# Access Compliance Report

## Public Rights-of-Way

### (Curb Ramps)

Intersection ID: 10018219	Main Street: MUMFORD_LN	Cross Street: N/A	Location: W
ADA ID: 5F119515A2DB	Ramp Type: Perp	Initial Pass/Fail: Fail	Overall Compliance: No
Severity Score: 12.5			
Codes/Mitigation Info/Possible Solution		Field Measurements/Component Compliance

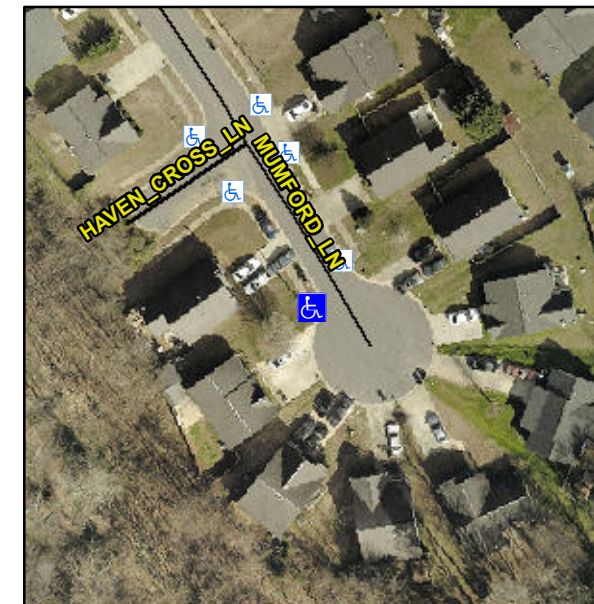
**Not Found, R304.2.2**

Compliance	Description	Data	Compliance	Description	Data
N/A	Ramp Length (in)	25.5	No	Ramp Slope (%)	9.7
Yes	Ramp Width (in)	48.0	Yes	Ramp XSlope (%)	1.0
N/A	Flare Type LT	N/A	N/A	Flare Type RT	N/A
N/A	Flare Slope LT (%)	N/A	N/A	Flare Slope RT (%)	N/A
N/A	Flare Traversable LT?	N/A	N/A	Flare Traversable RT?	N/A
N/A	Landing Length (in)	N/A	N/A	DWS Provided?	N/A
N/A	Landing Width (in)	N/A	N/A	DWS Contrast?	N/A
N/A	Landing Slope (%)	N/A	N/A	DWS Length (in)	N/A
N/A	Landing X Slope (%)	N/A	N/A	DWS Full Width?	N/A
N/A	Landing Curb? (Y/N)	N/A	N/A	DWS Offset (in)	N/A
N/A	Shared Landing?	N/A			
N/A	Gutter Ponding?	N/A	N/A	Gutter Slope (%)	N/A
N/A	Gutter Lip Ht (in)	N/A	N/A	Gutter X Slope (%)	N/A
N/A	Painted X Walk1?	No	N/A	Painted X Walk2?	N/A
	X Walk 1 Direction	To NE		X Walk 2 Direction	N/A
N/A	X Walk 1 Width (in)	N/A	N/A	X Walk 2 Width (in)	N/A
	X Walk 1 Slope (%)	0.3		X Walk 2 Slope (%)	N/A
	X Walk 1 X Slope (%)	3.1		X Walk 2 X Slope (%)	N/A

**Remove & Replace Entire Ramp.**
